LEHIGH RIVER BASIN,
POHOPOCO CREEK, PENNSYLVANIA .

BELTZVILLE LAKE.

CONDITION REPORT.
DAM, OUTLET WORKS & SPILLWAY
PERIODIC INSPECTION REPORT, NO. 1,

JULY 1970.

Photo No. 4 Minor crack in left wing wall -
outlet works.

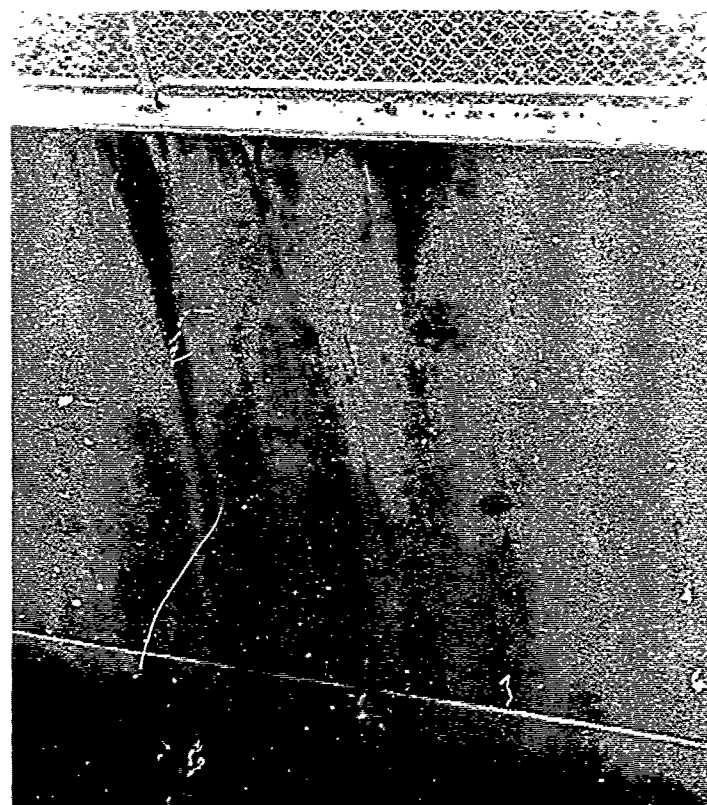
(2) Stilling basin walls: Photographs 4 and 5 show a minor crack and a joint spall in the left basin wall. No repair needed.

Photo No. 6 Potential undermining of guard
rail downstream of outlet works.

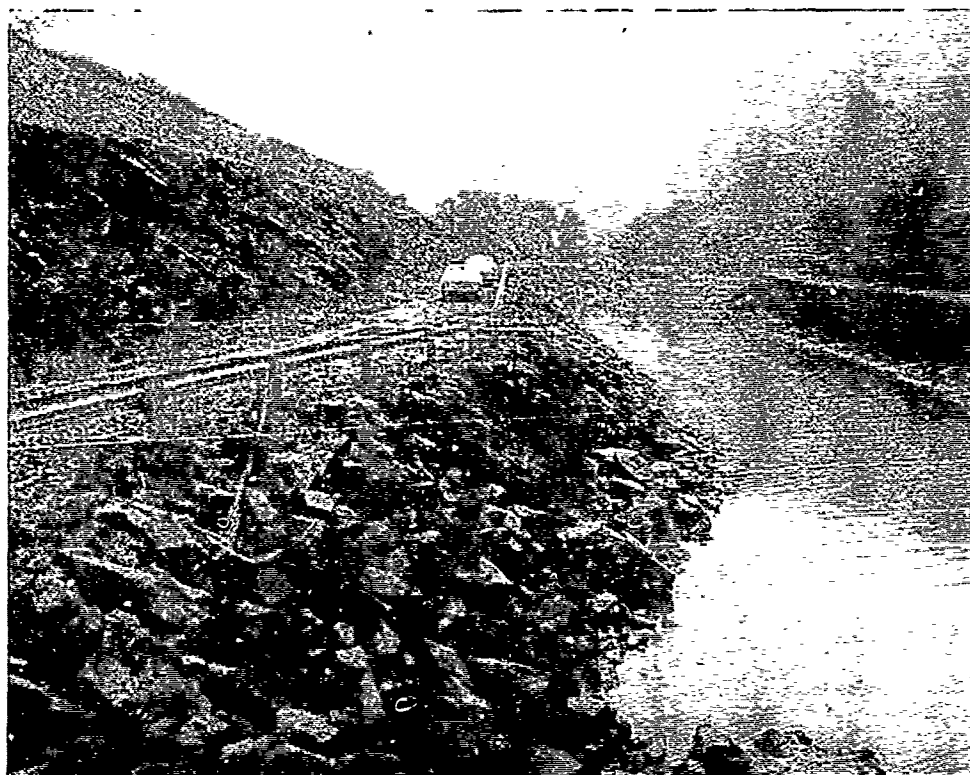
(3) Outlet works area: Photographs 6, 7 and 8 show areas of possible future erosion problems and were taken for comparison purposes only. Captions identify the area.
